# UNITED STATES PATENT AND TRADEMARK OFFICE

APPLICATION NO.	FILING DATE	FIRST NAMED INVENTOR	ATTORNEY DOCKET NO.	CONFIRMATION NO.
10/606,270	06/26/2003	Michihiro Shibata	Q76017	3378
23373	7590	02/08/2006	EXAMINER	
SUGHRUE MION, PLLC 2100 PENNSYLVANIA AVENUE, N.W. SUITE 800 WASHINGTON, DC 20037			CHEN, TIANJIE	
			ART UNIT	PAPER NUMBER
			2656

## Office Action Summary

## ***Final Rejection***

FIG. 4

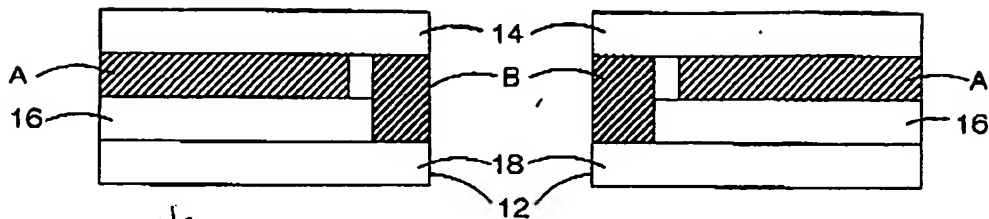
1. New corrected drawings in compliance with 37 CFR 1.121(d) are required in this application because newly submitted drawings Figs 4 and 5 are not accepted for two reasons: (1) it contains new matter as described in following “new matter” rejection, (2) The drawings are objected to under 37 CFR 1.83(a). The drawings must show every feature of the invention specified in the claims. Therefore, the “another layer having a shape that is substantially the same as that of the transparent substrate” must be shown or the feature(s) canceled from the claim(s). No new matter should be entered.

Do not enter it.  
Chen 02/03/06

FIG. 5

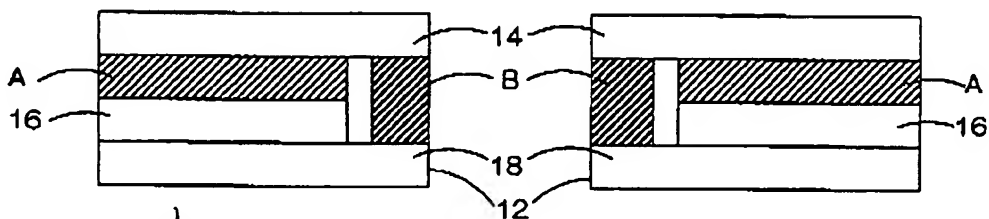
Do not enter it.  
Chen 02/03/06
